RE: JMC Project 23050
 Majidi Subdivision
 21 Whippoorwill Road
 Town of North Castle, NY
 Tax Lot 107.04-1-11

Response to Comment Memoranda Received from the Planning Department and KSCJ Consulting

ZONING COMPLIANCE PLAN
MAJIDI SUBDIVISION
21 WHIPPOORWILL ROAD
NORTH CASTLE, NY 10504

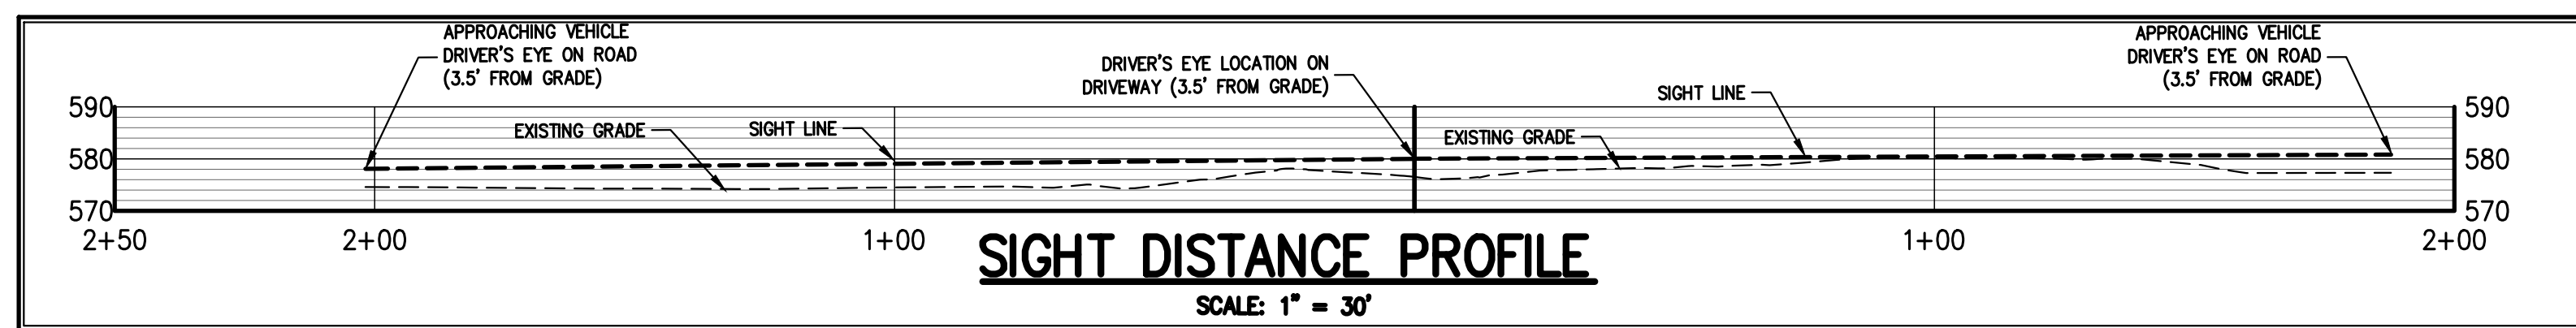
The net and gross lot area on the Table of Land Use don't match the information on Plan C-020. The data should be corrected and coordinated.

The applicant should prepare and submit a Zoning Compliance Plan which documents the deductions required on each proposed lot in arriving at net lot area. The applicant should also include on the plan the contiguous buildable area for each lot.

The table has been reviewed and corrected accordingly.

A Zoning Compliance Plan has been added as requested.
